Access Compliance Report Public Rights-of-Way (Curb Ramps)

Intersection ID: 13292 Main Street: E 3RD ST **Cross Street: S MCDOWELL ST** Location: W **ADA ID: 92ABE724EBBE** Ramp Type: PerpDiag Initial Pass/Fail: Fail **Overall Compliance: No Severity Score:** 10

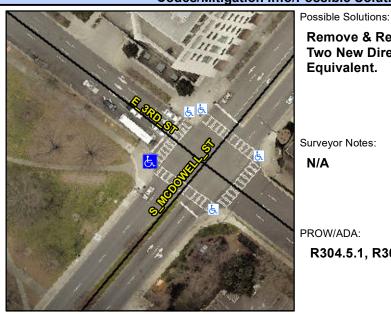
R304.5.1, R304.5.3

Compliance Description Data Compliance Description Data					
Compliance Description		Data	Compliance Description		Data
N/A	Ramp Length (in)	93.0	Yes	Ramp Slope (%)	6.6
No	Ramp Width (in)	46.0	No	Ramp XSlope (%)	2.5
N/A	Flare Type LT	N/A	N/A	Flare Type RT	N/A
N/A	Flare Slope LT (%)	N/A	N/A	Flare Slope RT (%)	N/A
N/A	Flare Traversable LT?	N/A	N/A	Flare Traversable RT?	N/A
N/A	Landing Length (in)	N/A	N/A	DWS Provided?	N/A
N/A	Landing Width (in)	N/A	N/A	DWS Contrast?	N/A
N/A	Landing Slope (%)	N/A	N/A	DWS Length (in)	N/A
N/A	Landing X Slope (%)	N/A	N/A	DWS Full Width?	N/A
N/A	Landing Curb? (Y/N)	N/A	N/A	DWS Offset (in)	N/A
N/A	Shared Landing?	N/A			
N/A	Gutter Ponding?	N/A	N/A	Gutter Slope (%)	N/A
N/A	Gutter Lip Ht (in)	N/A	N/A	Gutter X Slope (%)	N/A
N/A	Painted X Walk1?	Yes	N/A	Painted X Walk2?	Yes
	X Walk 1 Direction	To SE		X Walk 2 Direction	To NE
N/A	X Walk 1 Width (in)	107.0	N/A	X Walk 2 Width (in)	107.0
	X Walk 1 Slope (%)	1.2		X Walk 2 Slope (%)	2.6

Remove & Replace Curb Ramp With Two New Directional Ramps or Equivalent.
